SHOWING PROPOSED ADD: & ALTERATIONS.
ON PLOT NO 10 S.R. 7.

With reference to your application dated 4-12-34
with a plan for the proposed building/additions and alterations on plot
No. 10/2, Survey Sheet No. S.R.7, Serai Quarter
I have to request you to comply with the following requirements:—

AMENDED PLAN.
SHOWING PROPOSED ADD: & ALTERATIONS
ON PLOT NO 10/5.R.7.
SERAI QUARTER
SCALE 8-1.

FINAL PLAN.

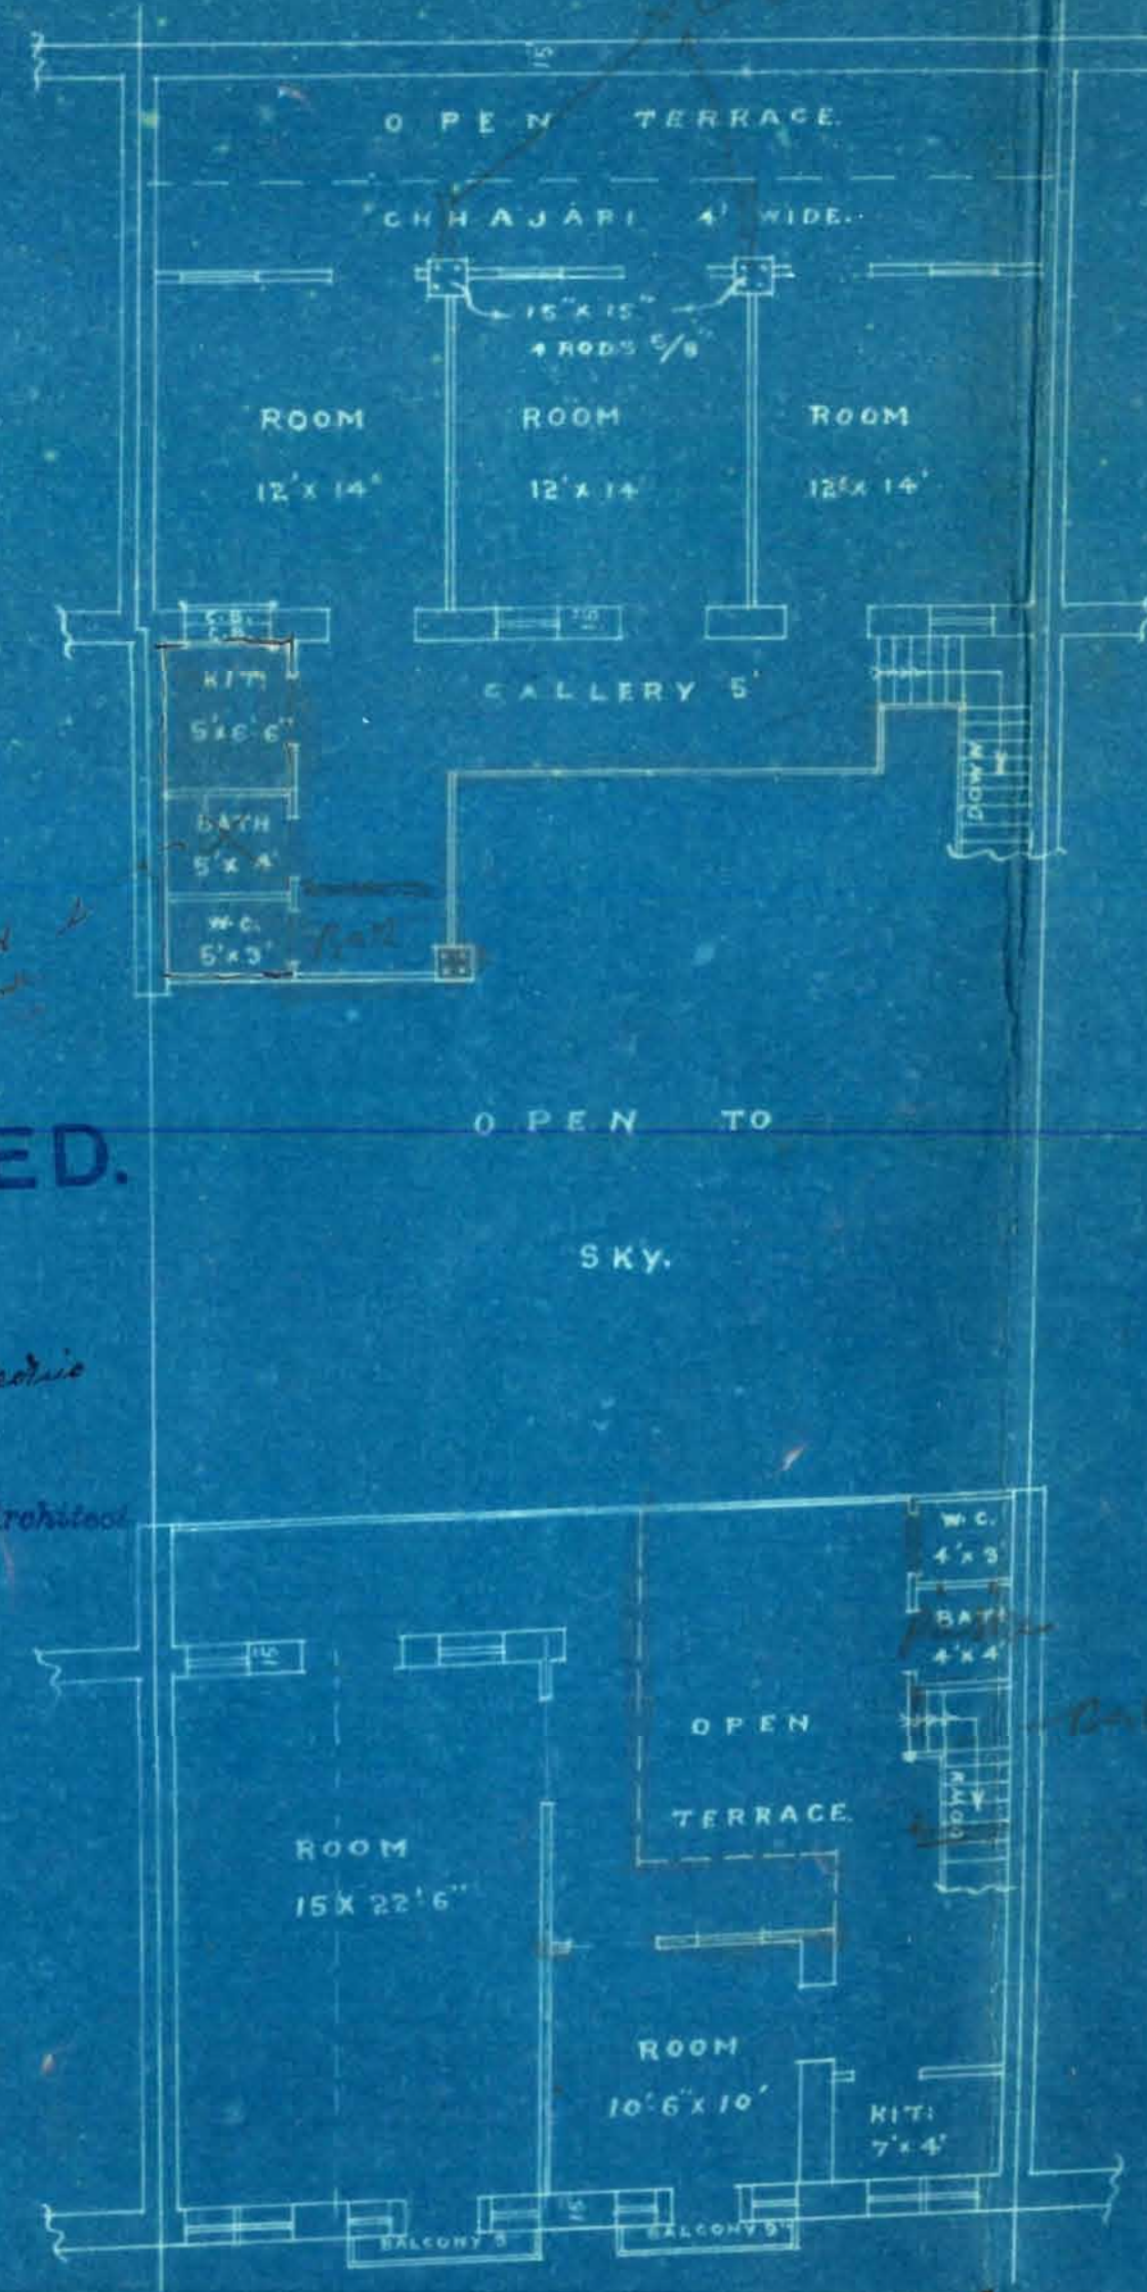
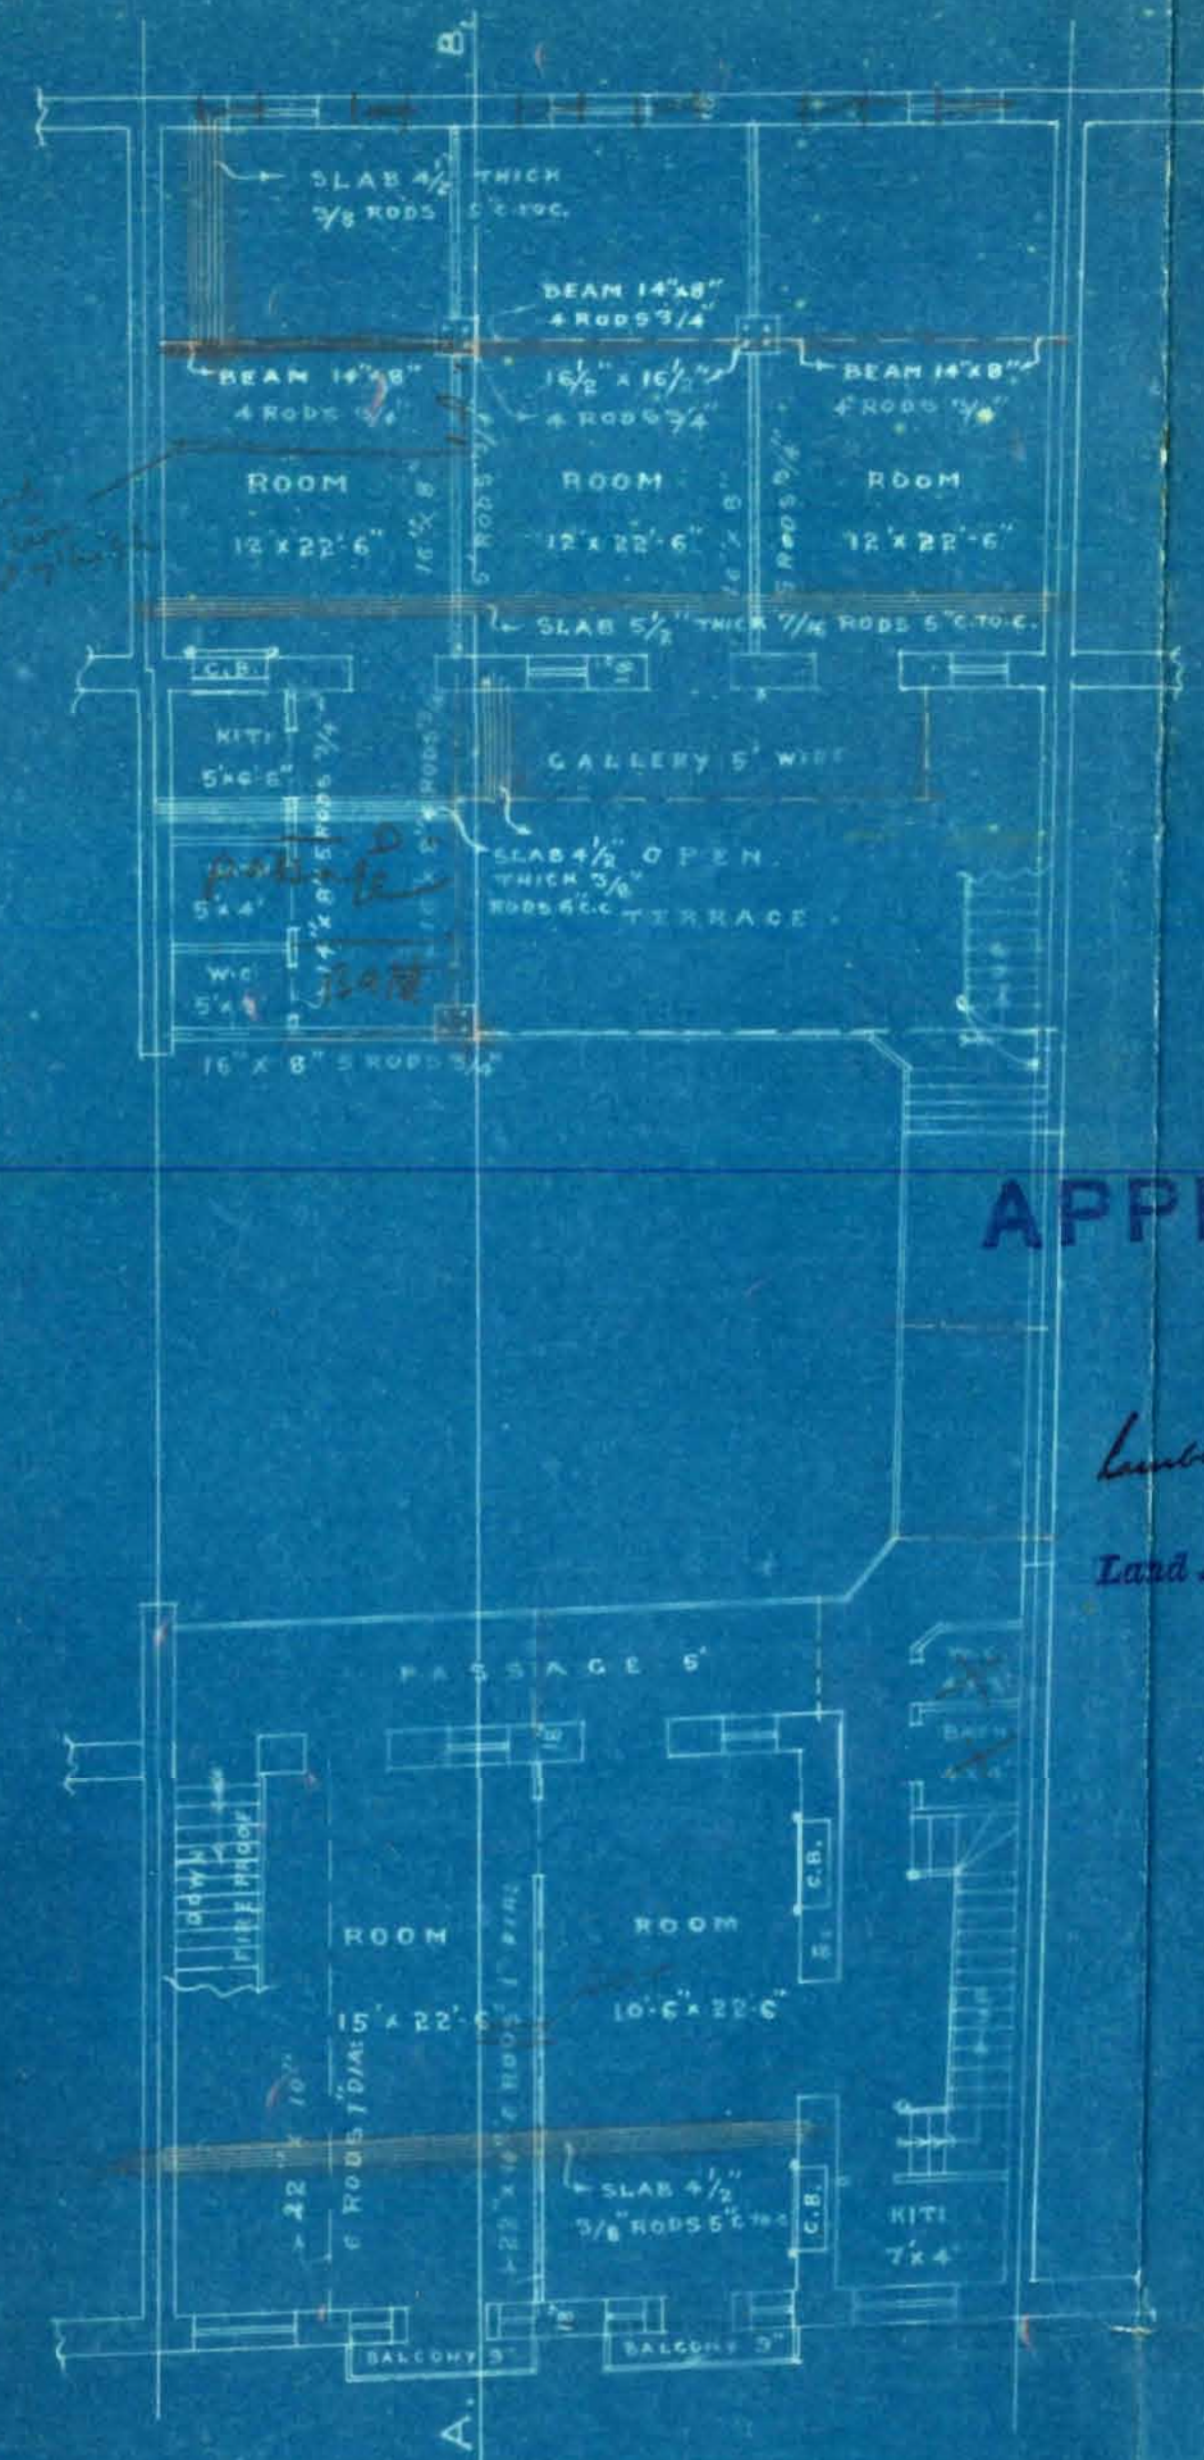
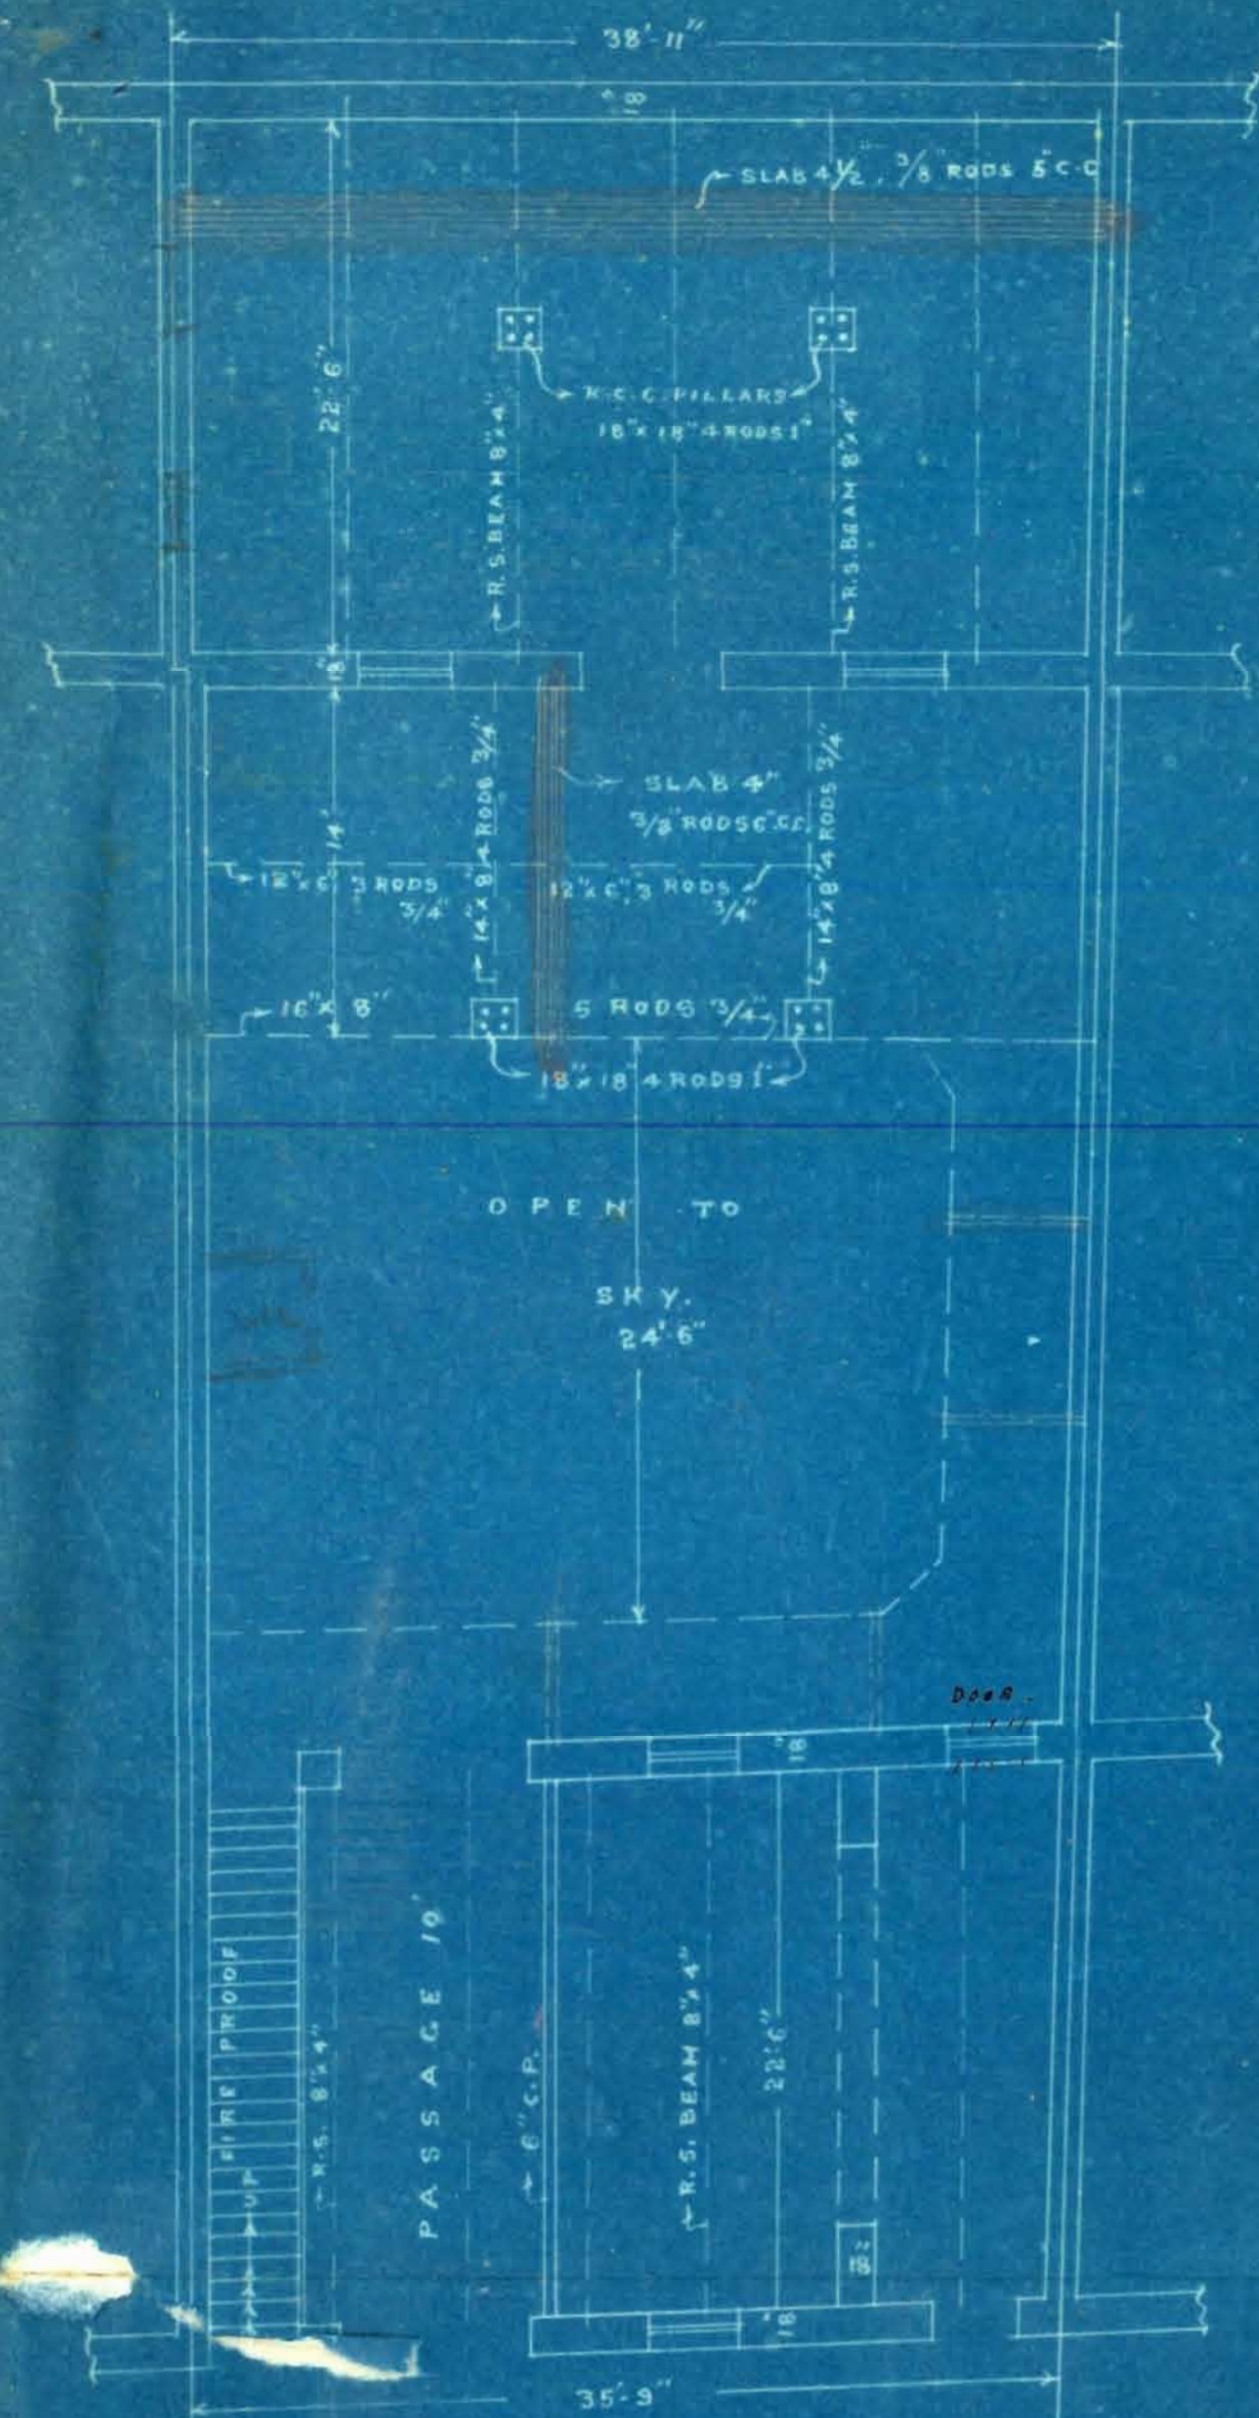
1. W.C. against rule above a ~~garage~~ godown.
- ✓ 2. The authority of subdivision must be produced.

With reference to your application dated 29-1-35
 with a plan for the proposed building/additions and alterations on plot
 No. 10/2, Survey Sheet No. S.R. 7 Serai Quarter
 I have to request you to comply with the following requirements:—

1. Requirements of the Health Officer must be complied with for which you are requested to please see him in the Office.

- ✓ 1. Requirements of the Health Officer must be
complied with for which you are requested to
please see him in the Office

B.S.P.C 298/34 dated 22 Dec 1934 regarding plan
of building on plot No: 10/2 sheet S.R. 7 Seral
Quarter we beg to state as under:-

1. Position of w.c. is same as shown in the approved plan.
2. With regard to the subdivision exam the same is shortly to be approved as practically there is no objection as the requirements of the City Deputy Collector's office have been complied with.

More over this being an amended plan we
trust you will pass the plan.

Sambucetto.Requirement has been
complied withplan approved
15/2no objection
14-2-35
